Amarillo LE- ADA Evaluation

LE-Amarillo TX, ADA Evaluation
203 SW 8th Ave
Amarillo, TX 79101
Accessibility Evaluation
Inspection Date: 01/17/2023
Inspectors: Jessica Burke

Report Date: 01/12/2024

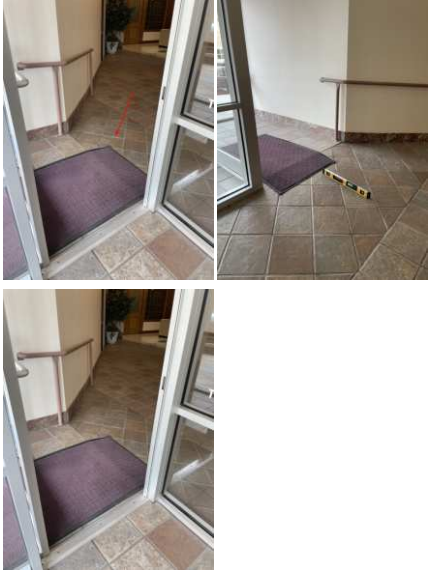
Finding Number	Area Description	Finding	As Built	Recommendation	Citation	Photos	Figure
7	Exterior of Property (Public) : Parking Off Street (2 Spaces) 2 Labeled - Access Aisle Requirments (Van)	The access aisle is not located on an accessible route of travel to the accessible building entrance. Accessible parking spaces serving a particular building shall be located on the shortest accessible route of travel from parking to an accessible entrance. In buildings with multiple accessible entrances with adjacent parking, accessible parking spaces shall be dispersed and located closest to the accessible entrances.	Curb prevent access to sidewalk.	https://www.access-board.gov/ada/#ada-208_3_1	2012 TAS Section: 208.3.1 2010 ADAS Section: 208.3.1, 502.3		
8	Exterior of Property (Public) : Parking Off Street (2 Spaces) 2 Labeled - Accessible Stall (Labeled #2)	The parking space is in not nearly compliant. The parking space the minimum width. The floor or ground surface is not firm stable or slip resistant. The parking space contains changes in level and/or gaps that exceed the maximum allowable requirements. The parking space does not have the proper identifications signs or the signs are not installed at the correct height. The parking space is missing an adjacent access aisle.	Accessible spot located on street. No designated markings for space dimensions or access aisle	https://www.access-board.gov/ada/#ada-502_1	2012 TAS Section: 502.1, 502.1 Exception 2010 ADAS Section: 502.1, 502.1 Exception

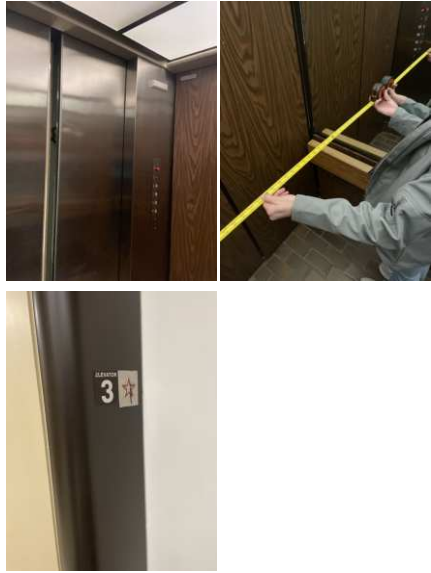
Finding Number	Area Description	Finding	As Built	Recommendation	Citation	Photos	Figure
22	First Floor Main Building LOBBY (Public): Lobby Area - Restroom (Men's)	The lavatory is too close to the side wall. There must be a minimum of 15 inches from the centerline of the lavatory to the nearest side wall or side partition to allow for an unobstructed 30 inches by 48 inches clear floor space.	Lavatory centerline measures at 14.5" from side wall	https://www.access-board.gov/ada/#ada-606_2	2012 TAS Section: 606.2 2010 ADAS Section: 606.2		
23	First Floor Main Building LOBBY (Public): Lobby Area - Restroom (Men's)	The lavatory's clear floor space is not a minimum 30 inches wide by 48 inches deep. A 30 inch by 48 inch clear floor space positioned for a forward approach with knee and toe clearance shall be provided.	Trash can placement impedes access	https://www.access-board.gov/ada/#ada-606_2	2012 TAS Section: 606.2 2010 ADAS Section: 606.2
